January 23, 2009

IRVINGTON WATERFRONT STUDY
Village of Irvington, NY

Prepared by:
BFJ Planning
115 Fifth Avenue
New York, NY 10003
In Association with:
Gregg C. DeAngelis Architects

This draft study was prepared by BFJ Planning at the request of the Village Board of Trustees to help them evaluate a zoning amendment petition and development proposal submitted by Bridge Street Properties, LLC on February 13, 2007 for a 3- acre waterfront parcel located in the Village of Irvington, New York. As of the date of its publication by the Board of Trustees (January 23, 2009), this study does not represent the position of, and has not been endorsed by, the Board of Trustees.

South Lot Deck

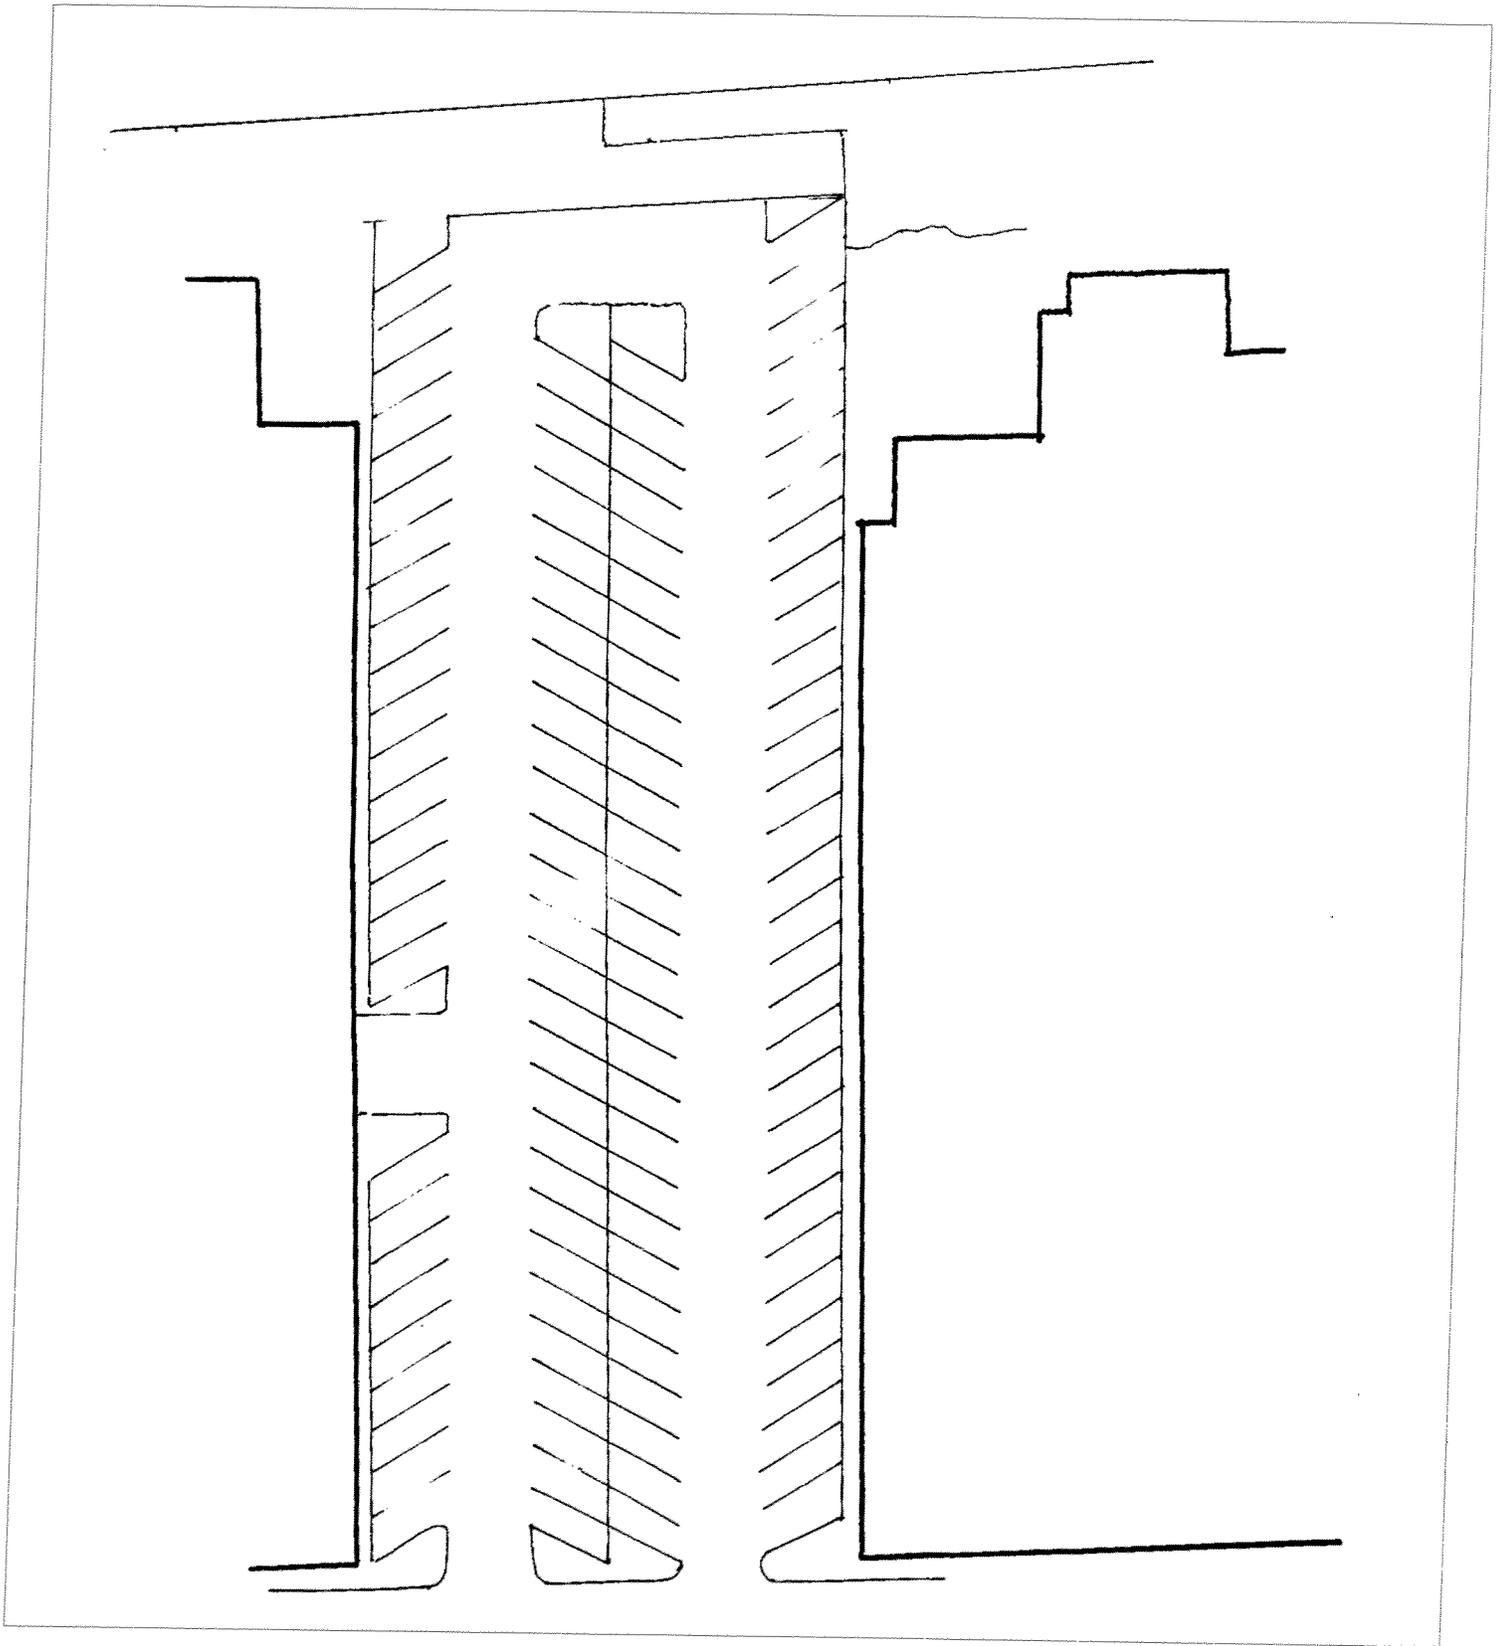
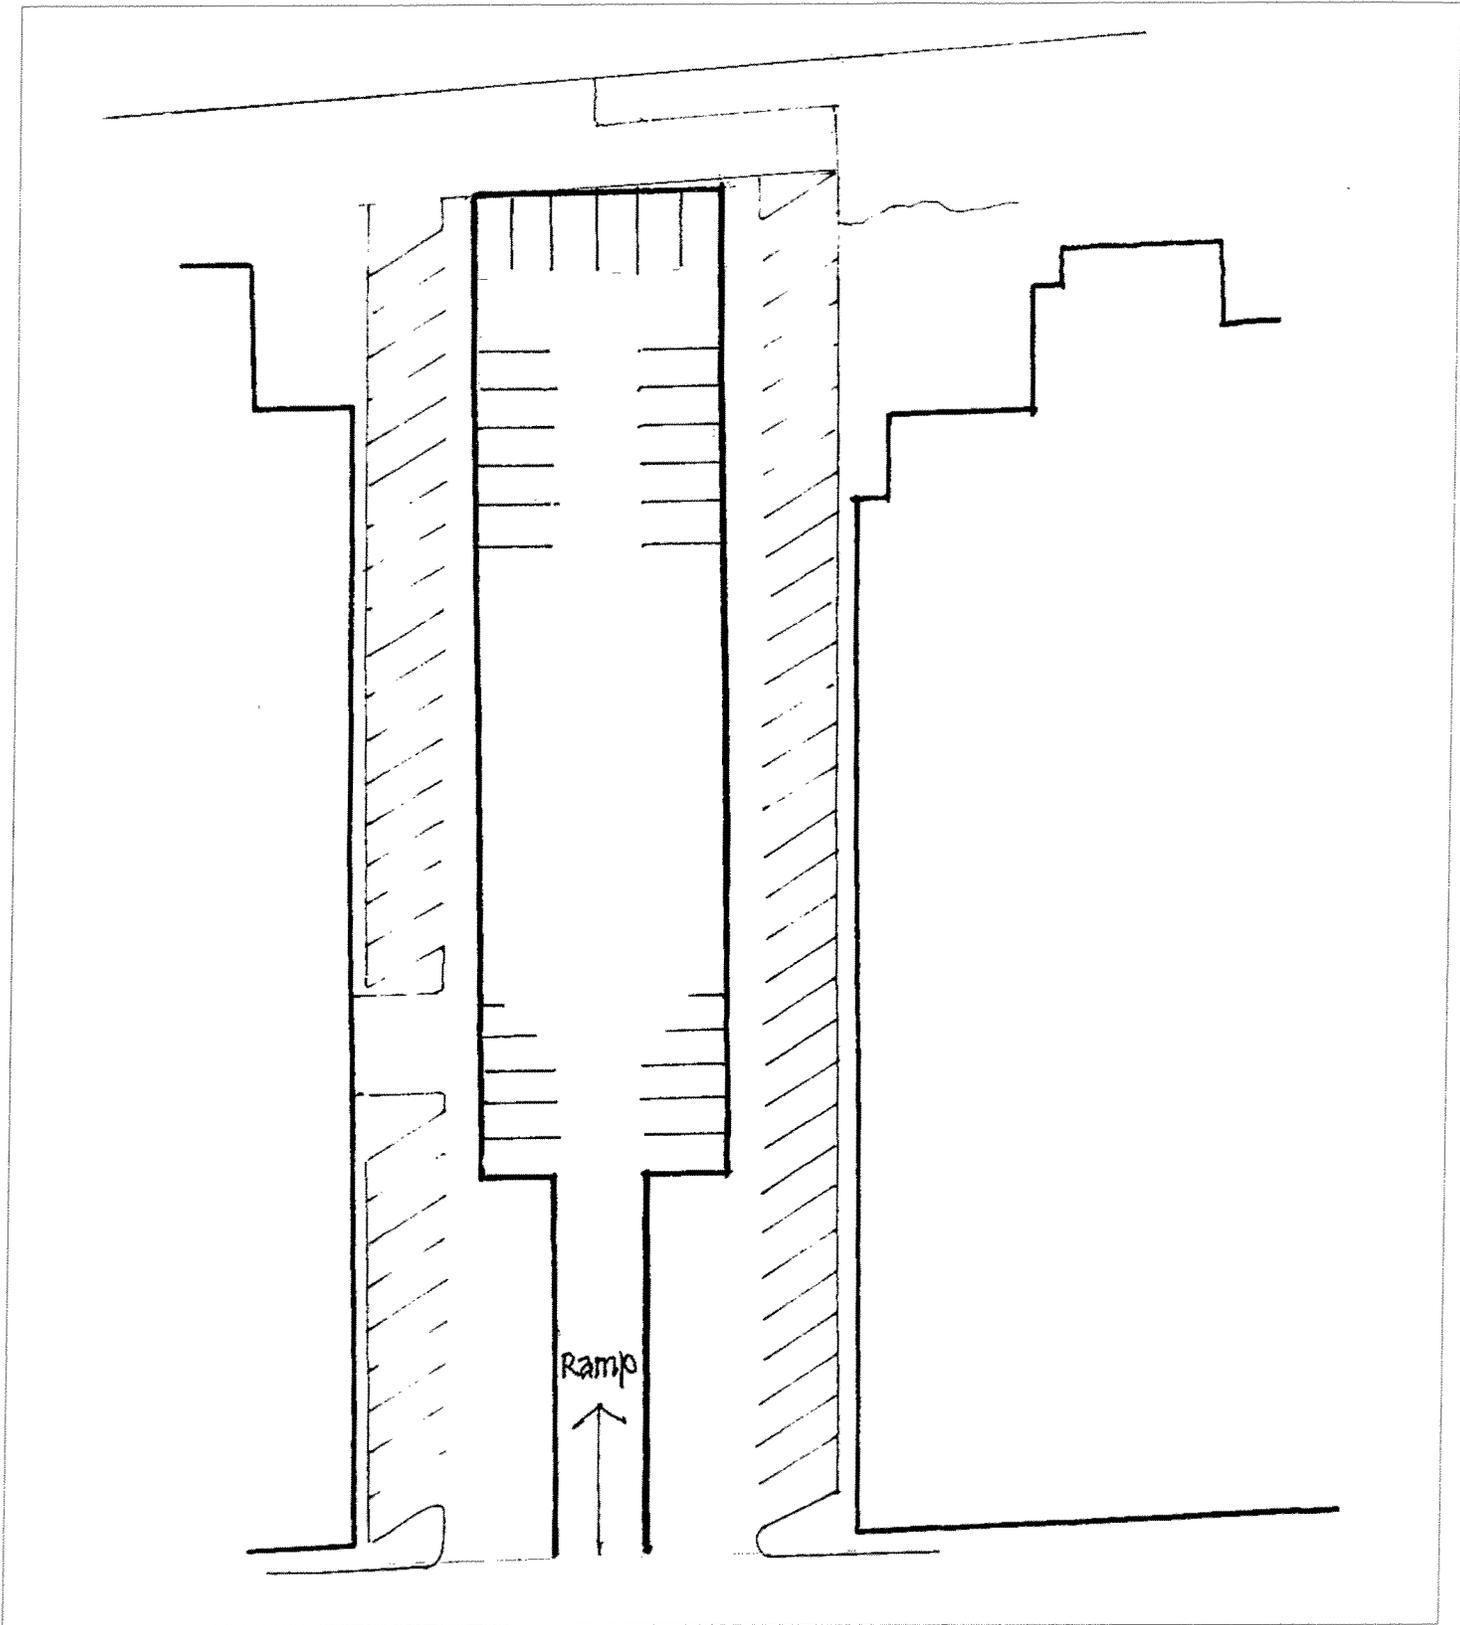
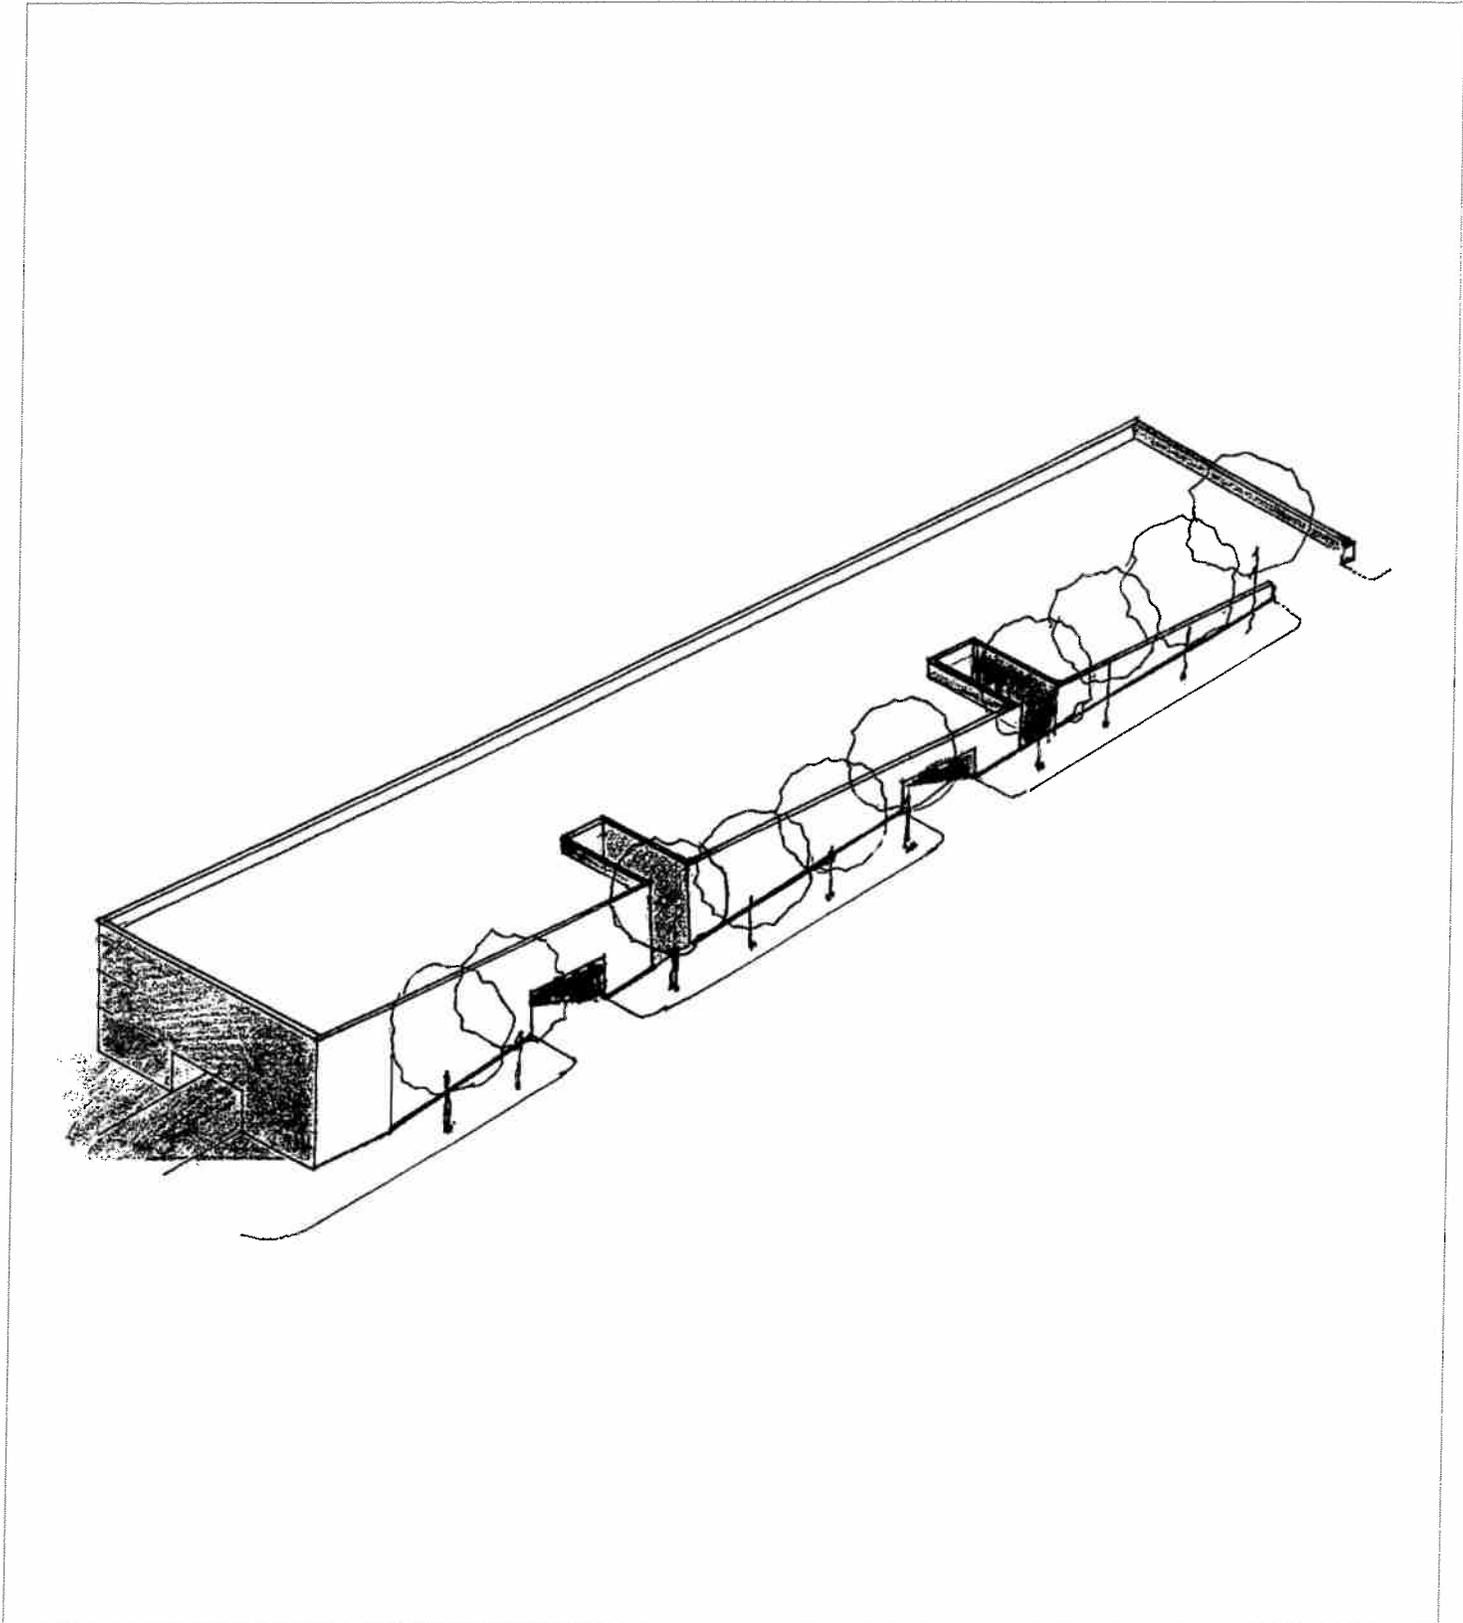
This allows for two aisles giving access to diagonal parking bays as shown in figure 1. Adding a parking deck at this location poses a number of problems:

- The deck width is constrained by the need to maintain daylight to adjacent buildings
 - Approximately 16 surface spaces are lost due to the need of the entry/exit ramp to the deck
 - Additional existing 8 spaces are likely to be lost due to the need for column supports for the deck.
- Figure 2 illustrates a possible one-level deck solution that provides approximately 56 spaces. The net gain is a maximum of only 40 spaces given the loss of existing spaces due to the ramp and the support columns. This total compares to the 60 spaces provided on each level of the proposed Bridge Street garage.

The cost of the new deck would be at least \$25,000 per space or approximately \$1,400,000.00 (25000x56 spaces). However the net cost per new space (\$1.4m/40) is \$35,000/space. This does not assume any costs for piles which may be needed in this area. We will need to ask the applicant for additional subsurface information to see whether piles would be necessary. Given the decks proximity to the bulkhead we assume they may be needed at least at the western end.
